# Access Compliance Report

## Public Rights-of-Way

### (Curb Ramps)

Intersection ID: 18172	Main Street: FOREST_GREEN_DR	Cross Street: LITTLE_MOSER_LN	Location: SW
ADA ID: D7FCFB1DA109	Ramp Type: PerpDiag	Initial Pass/Fail: Fail	Overall Compliance: No
Severity Score: 21.25			
Codes/Mitigation Info/Possible Solution		Field Measurements/Component Compliance

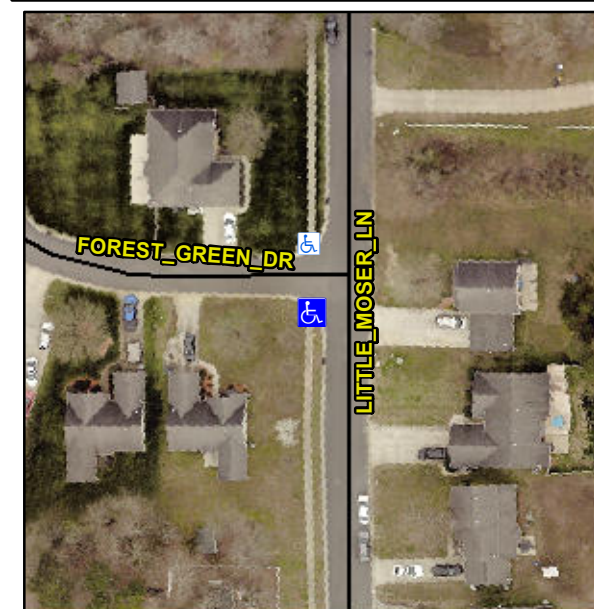
**Not Found, R304.5.1, R304.2.2**

Compliance	Description	Data	Compliance	Description	Data
N/A	Ramp Length (in)	50.0	No	Ramp Slope (%)	8.6
No	Ramp Width (in)	39.0	Yes	Ramp XSlope (%)	0.5
N/A	Flare Type LT	N/A	N/A	Flare Type RT	N/A
N/A	Flare Slope LT (%)	N/A	N/A	Flare Slope RT (%)	N/A
N/A	Flare Traversable LT?	N/A	N/A	Flare Traversable RT?	N/A
N/A	Landing Length (in)	N/A	N/A	DWS Provided?	N/A
N/A	Landing Width (in)	N/A	N/A	DWS Contrast?	N/A
N/A	Landing Slope (%)	N/A	N/A	DWS Length (in)	N/A
N/A	Landing X Slope (%)	N/A	N/A	DWS Full Width?	N/A
N/A	Landing Curb? (Y/N)	N/A	N/A	DWS Offset (in)	N/A
N/A	Shared Landing?	N/A			
N/A	Gutter Ponding?	N/A	N/A	Gutter Slope (%)	N/A
N/A	Gutter Lip Ht (in)	N/A	N/A	Gutter X Slope (%)	N/A
N/A	Painted X Walk1?	No	N/A	Painted X Walk2?	No
	X Walk 1 Direction	To E		X Walk 2 Direction	To N
N/A	X Walk 1 Width (in)	N/A	N/A	X Walk 2 Width (in)	N/A
	X Walk 1 Slope (%)	3.3		X Walk 2 Slope (%)	1.8
	X Walk 1 X Slope (%)	4.5		X Walk 2 X Slope (%)	2.3

**Remove & Replace Curb Ramp With Two New Directional Ramps or Equivalent.**
